The West Group Ltd

PCN Date	PCN Number	Date of Implementation
December 2022	0832	Effective Immediately

E-F-160203 and E-F-210292

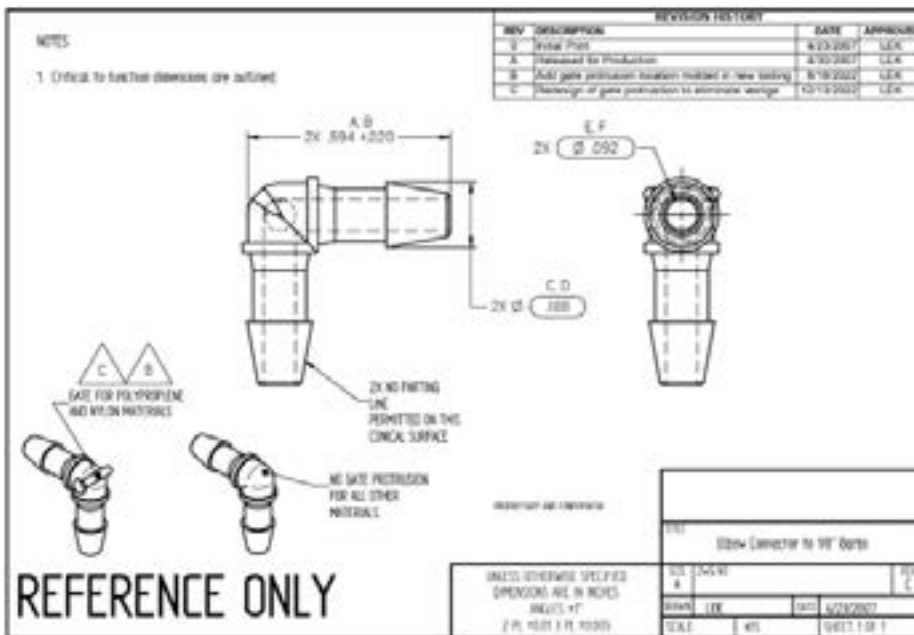
In response to ever-increasing demands for quality products and services, the manufacturer of this part is introducing higher-capacity tools. The process for manufacturing this product will have minimal change. While the mould base/inserts will be identical in specification with the equivalent moulding press, industry standard checks will be required to verify the 1:1 change. The upgraded injection point or gate requires a protrusion to allow for higher cavitation.

Verification and validation will consist of a limited re-qualification to confirm there will be no change to form, fit or function.
